Application of SOUTHERN CALIFORNIA
EDISON COMPANY, ET AL. for a Class 103
License to Acquire, Possess, and Use
a Utilization Facility as Part of
Unit No. 2 of the San Onofre Nuclear
Generating Station

}
Amendment Application
No. 123

This amendment application consists of Proposed Technical Specification
Change No. NPF-10-418 to Facility Operating License NPF-10. Proposed
Technical Specification Change No. NPF-10-418 is a request to include a new
Technical Specification 3.4.7.3.1, "Component Cooling Water Safety Related
Makeup System", and its associated Bases 3.4.7.3.1, in the San Onofre Unit 2
Technical Specifications.

DESCRIPTION AND SAFETY ANALYSIS
OF PROPOSED CHANGE NPF-10/15-418

SKETCH A

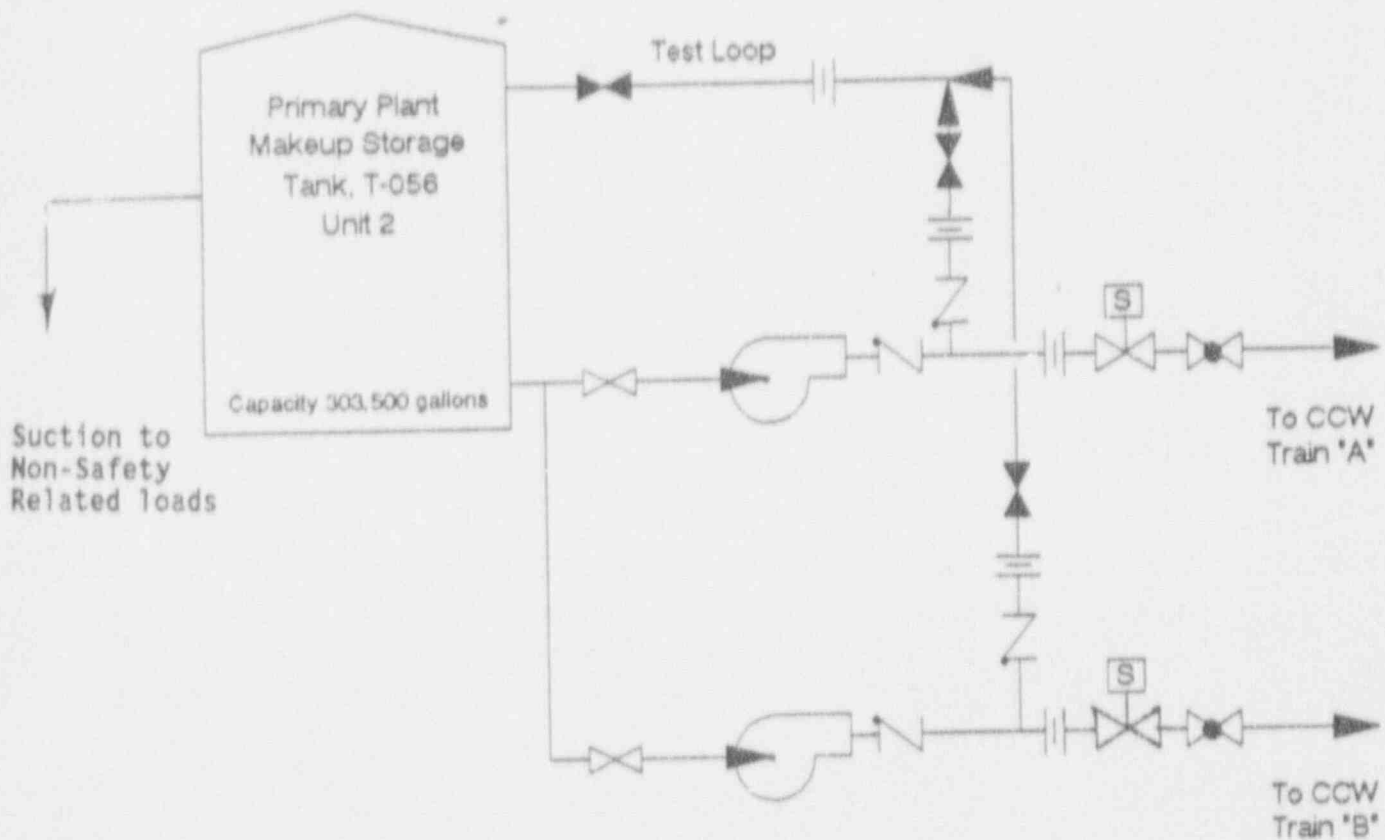
The Component Cooling Water Safety Related Makeup System for each unit will consist of one shared Primary Plant Makeup Storage Tank (PPMU Tank) and two redundant flow paths, each supplying a CCW critical loop as illustrated in Sketch A. Each Unit has its own PPMU Tank and redundant flow paths. Each flow path incorporates one 100% capacity pump. PPMU Tank T-056 is lined up for service to Unit 2 and T-055 for service to Unit 3.

"Two Trains of Component Cooling Water (CCW) Safety Related Makeup System shall be OPERABLE with a contained volume in the Primary Plant Makeup Storage Tank at or above the level specified in Figure 3.7-2."

The water source for the Component Cooling Water Safety Related Makeup System is the PPMU Tank. The total capacity of each PPMU Tank is approximately 303,500 gallons. The curve for PPMU Tank volume represents a seven day supply of makeup water at a specific allowable leakage rate from the CCW system. The requirement for seven days is consistent with Standard Review Plan, Section 9.2.2.III.c.
